**RE: SAMS Academy
6441 Ventana Rd. N.W.
Grading & Drainage Plan
Engineer's Stamp Date: 05/22/21
Hydrology File: A10D010**

Based upon the information provided in your submittal received 05/25/2021, the Grading & Drainage Plan **is not** approved for Building Permit, Grading Permit, and for action by the DRB on Site Plan for Building Permit. The following comments need to be addressed for approval of the above referenced project:

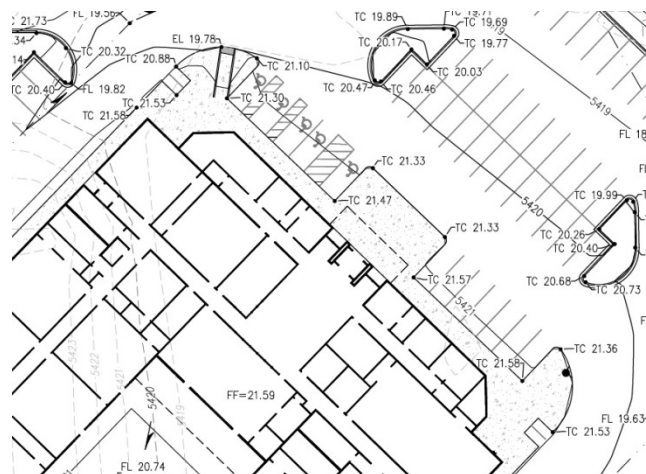
1. Sheet C1. Please just show the building outline. I do not need to see the rooms inside the building on the Grading & Drainage Plan. (See image on Comment #2 below)
2. Sheet C1. Please show the curb along the proposed sidewalk next to the building. This needs to look like all the other curbs that you have. With only a single line, it appears that the sidewalk is at the same elevation of the asphalt.

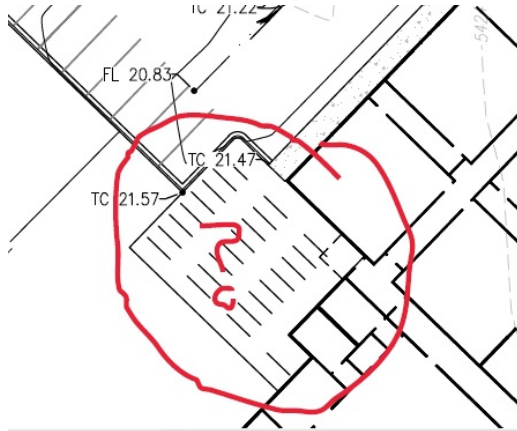
3. Sheet C1. What is this area at the northwest corner of the proposed building? If part of the building, than see comment #2. If concrete, than please provide a few grade points and label it.

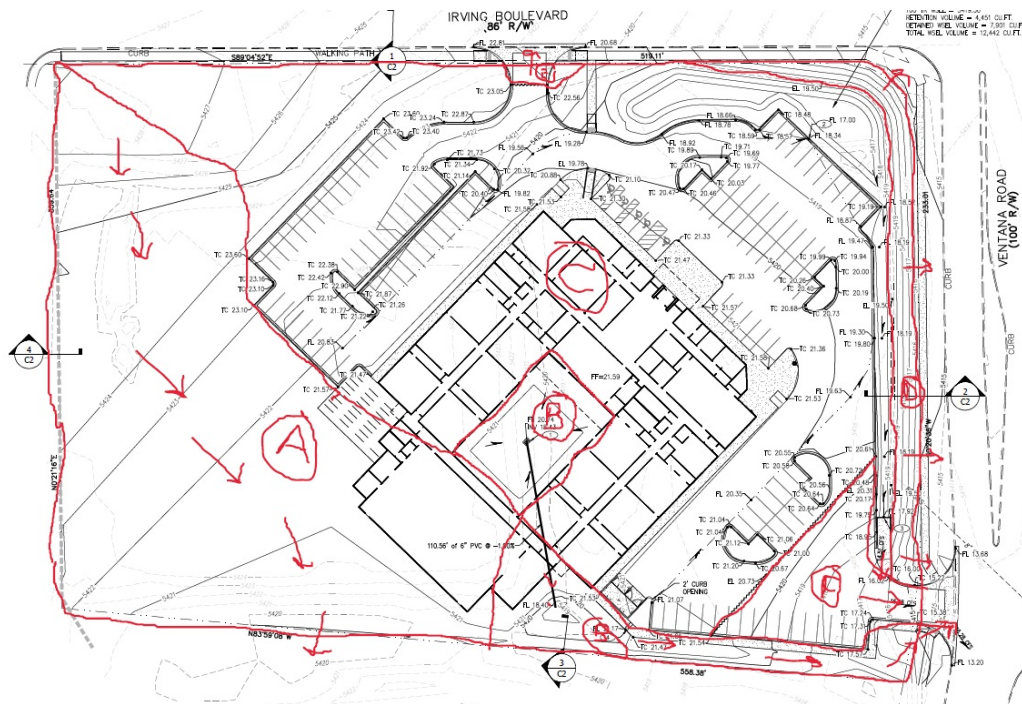
5. Sheet C1. Going off the proposed grades, there are six drainage areas with their own discharge points. (See photo below). Also please check with the architect to where the building's downspouts will be so that you can better determine what impervious area needs to be included. I have labeled them A – F. I will start off with the easiest drainage area E (the drive pad on Irving Blvd). This area is mainly from the waterblock to the property line and is mostly impervious which can freely discharge to Irving. Drainage area A (this is mostly type C but may have some of the building impervious runoff) has a point discharge into the City's Open Space property. This will need to detain the difference between the existing runoff and the proposed runoff onto this property. Drainage area B appears to be a portion of a courtyard within the building which does go to what appears to be a stormwater quality pond but this appears to then discharge down the south side of the property to Ventana Rd. This area will need to meet the allowable discharge rate of 3.93 cfs/ac. Since most of this area is type C I think it may be able to

achieve this. Drainage area D appears to sheet drain to Ventana Rd. This area will need to meet the allowable discharge rate of 3.93 cfs/ac. Since most of this area is type C I think it may be able to achieve this. Drainage area C is the biggest area but also is mostly impervious. Since this area needs to meet the discharge rate of 3.93 cfs/ac, I believe that the detention pond may not be big enough. And lastly drainage area F is entirely impervious and there is no stormwater quality for this drainage area and if this entire site is to freely discharge into Ventana Rd., then the discharge rate that drainage area C can add to this will have to be calculated by adding the drainage area C and F together to determine the allowable discharge and then subtract the free discharge of drainage area F. Please correct all calculations showing these six drainage area and show the proposed drainage map with the drainage areas and discharge for each area. You may also need to show the existing drainage areas as well, since this also looks to have at least two area on it, on draining onto the City's Open Space and the other onto Ventana Rd.

C 1

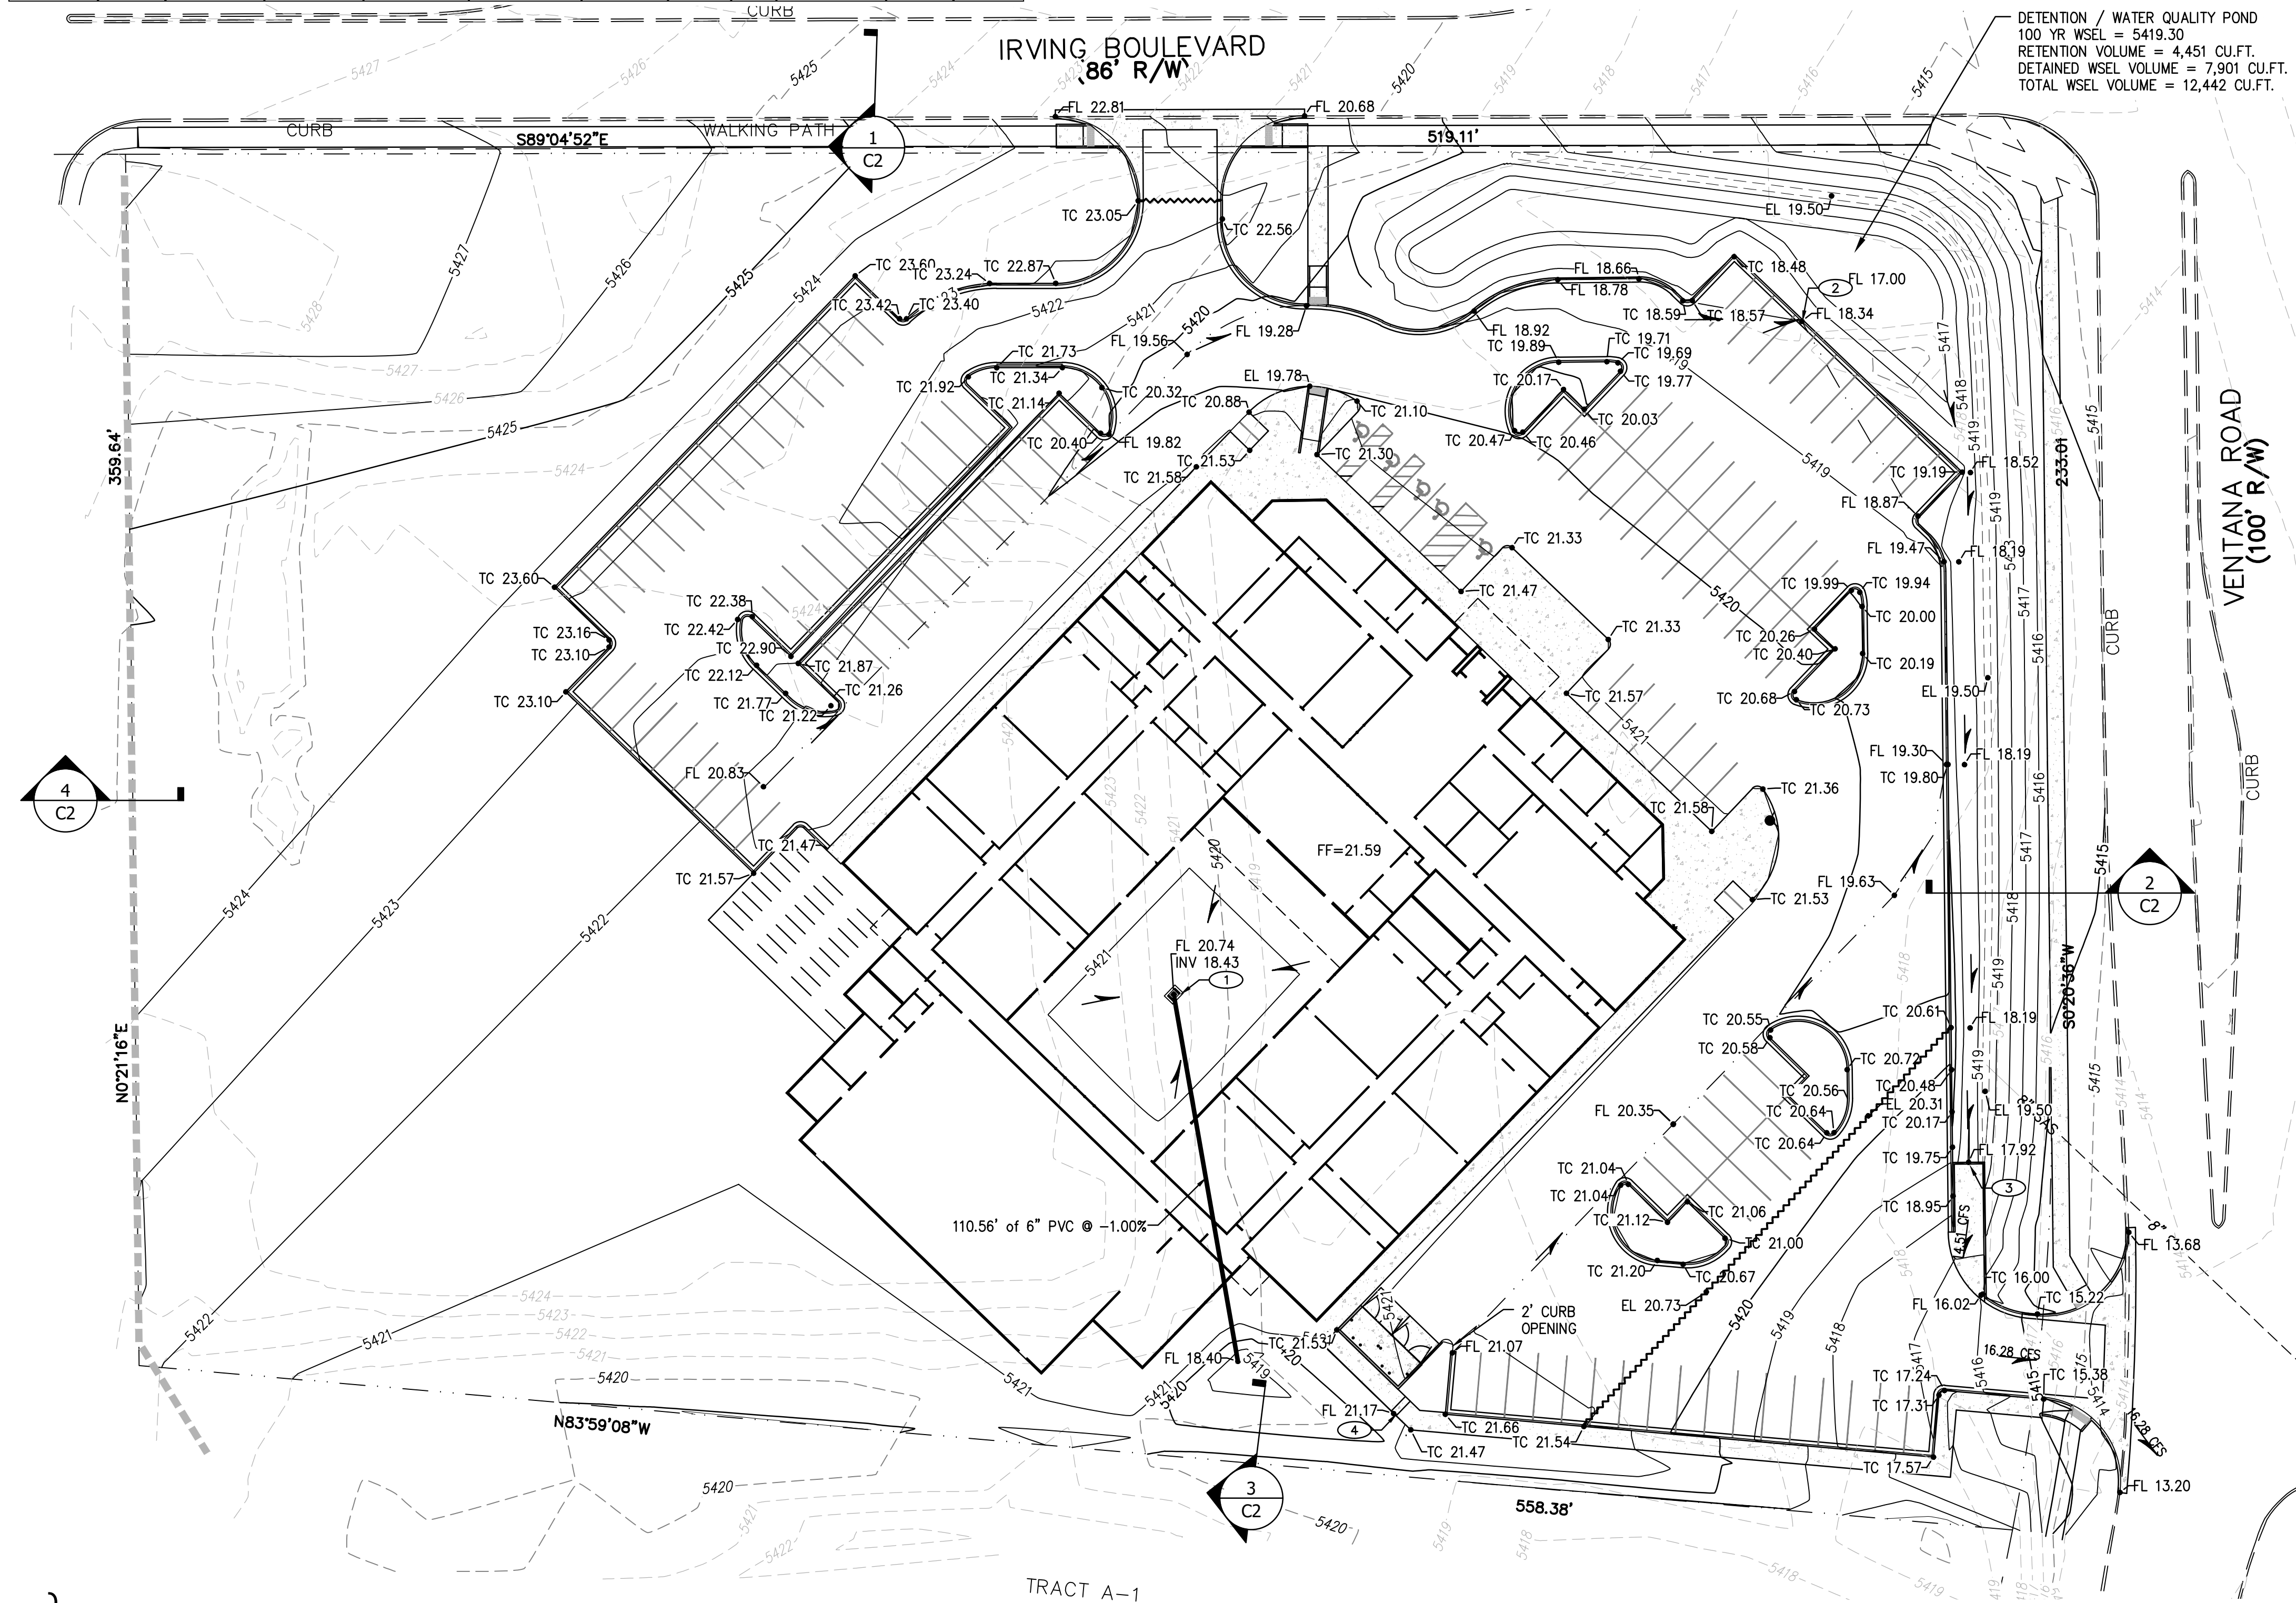
4. Sheet C1. Please show and label the existing asphalt trail along Irving Blvd. Also please note that there will be no grading within the R.O.W. so please terminate the grades at the property line at the same existing grade line.

6. Sheet C1. Please add the grade point at the east waterblock of the drive on Irving Blvd.
7. Sheet C1. Please provide the drainage calculations for the detention pond for drainage area C as outlined in Development Process Manual (DPM) (signed 06/08/20) Article 6-2(a).
8. Sheet C1. Please provide the weir calculations, per DPM Chapter Article 6-16(A), for the curb cuts and sidewalk culverts. A coefficient of 2.7 is typically used for the weir equation $Q = CLH^{2/3}$.
